Business Unit:	Electric	PCN/19/030/C+N-US
Product range:	Han HPR	Date: 01/20/2020
Title:	3HPR seal change	Page 1/2

HARTING Product Change Notification	PCN
---	--	------------

Old FPM O-Ring seal	New NBR O-Ring seal

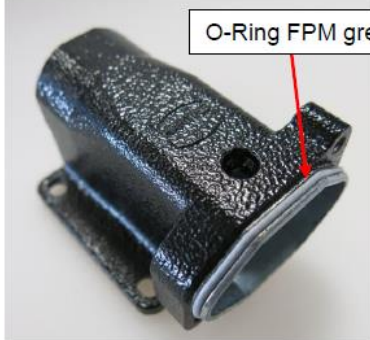
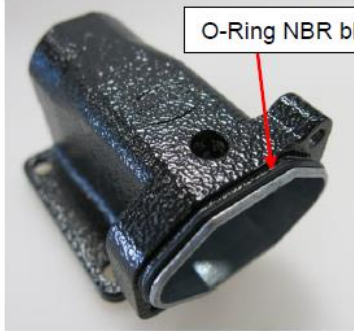
For the part numbers in Section 1, the O-ring material will change from FPM grey material to NBR black material.

Flange seals will remain the same in NBR material.
